**RE: Providence Master Plan Community
Project Plan: Architectural Plans
POD: 117 – Westminster
Plan Date: May 10, 2010**

From: Albert Sung
Sent: Thursday, May 12, 2011 9:14 AM
To: Kevin Berg
Cc: Robert Welch
Subject: Cliff's Edge POD 115, 116 & 117 - Unit 1B

CE POD 115, 116 AND 117 U1B
U.S. HOME

FIGURE 2
PROPOSED CONDITION

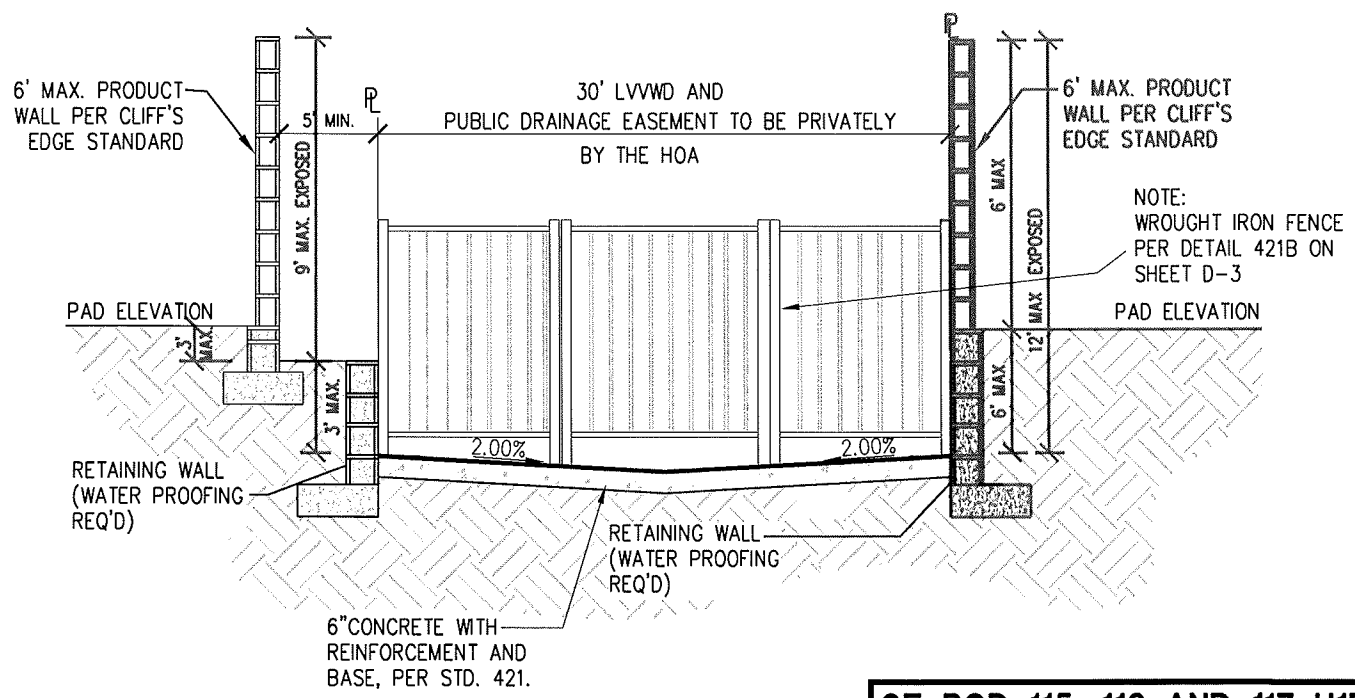
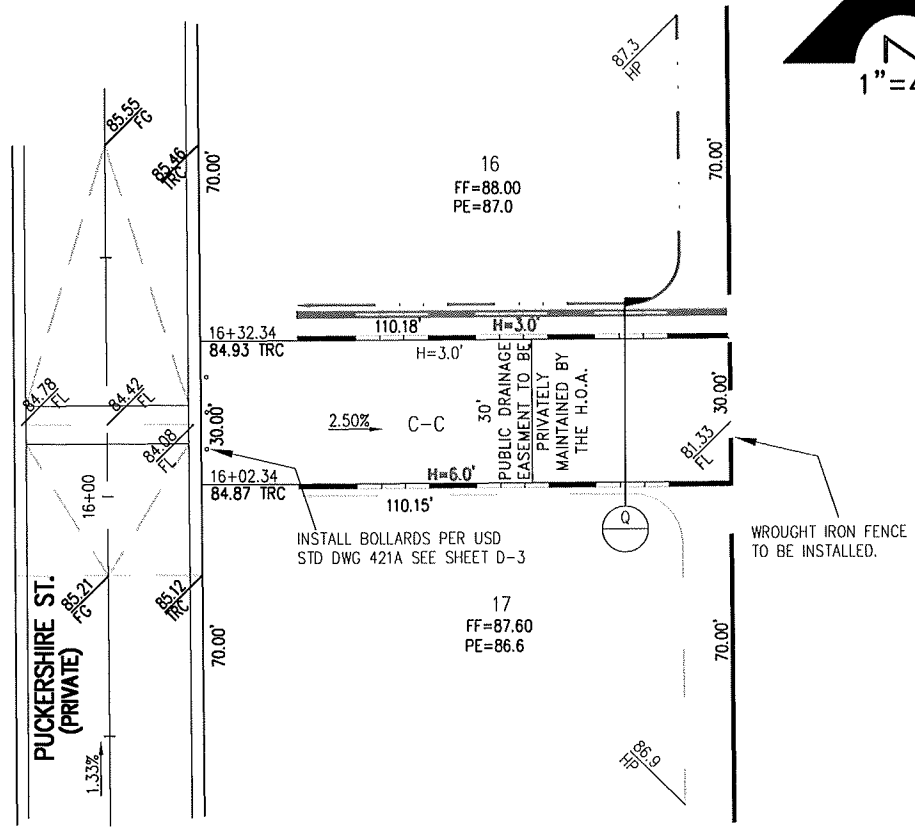
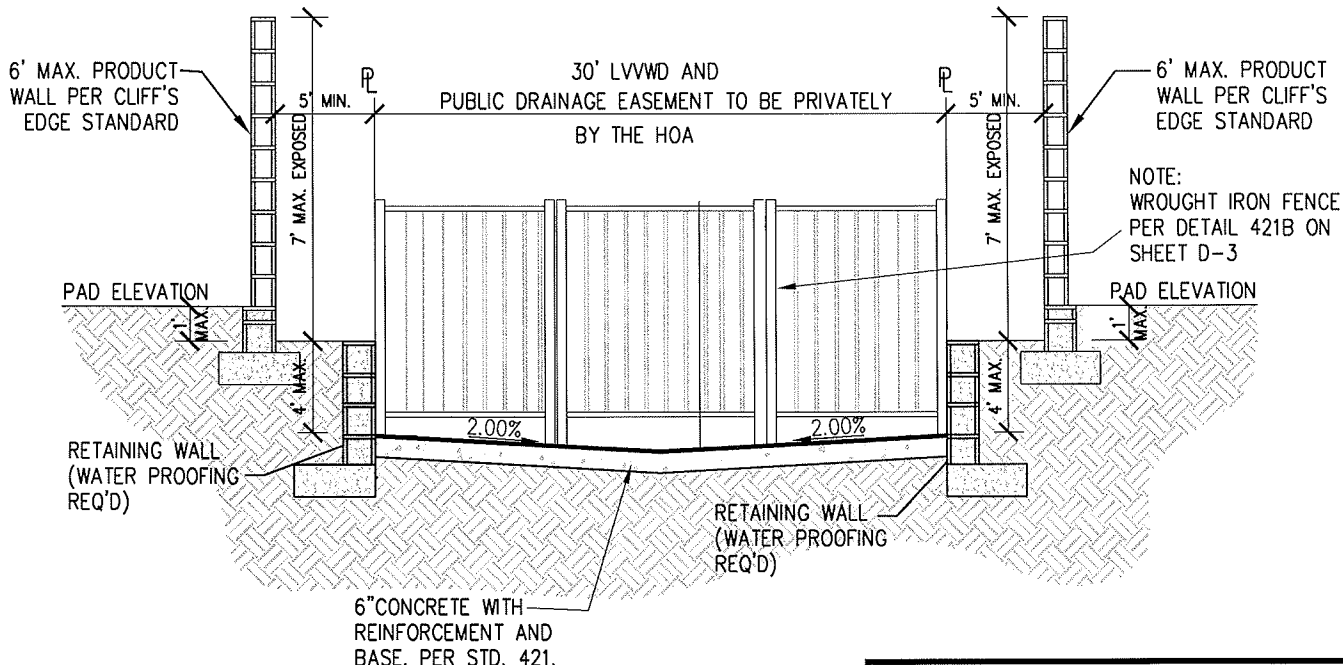
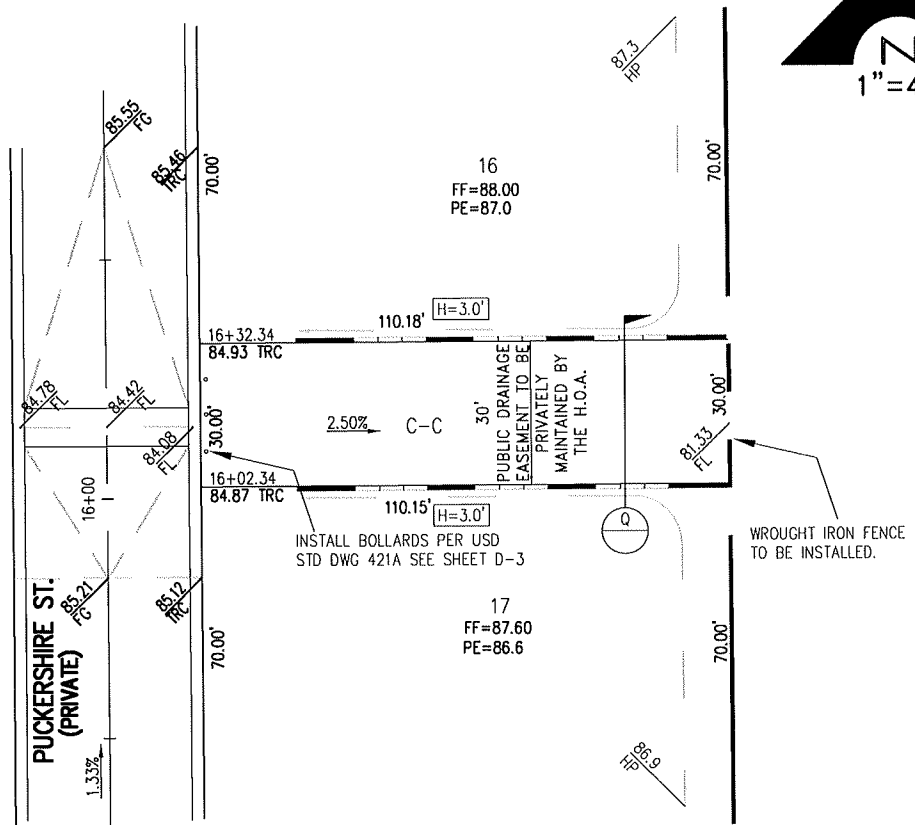
The Providence Design Review Committee (DRC) is in receipt of your plans indicating the detail Q D-1 will be revised on the improvement plans.

Flood Control had met with Lennar's engineer regarding the revision for adding a screen wall on top of an existing retaining wall adjacent to a public drainage easement. Flood Control has no concerns about the revision.

The DRC approves your improvement plans revision for the above referenced POD.
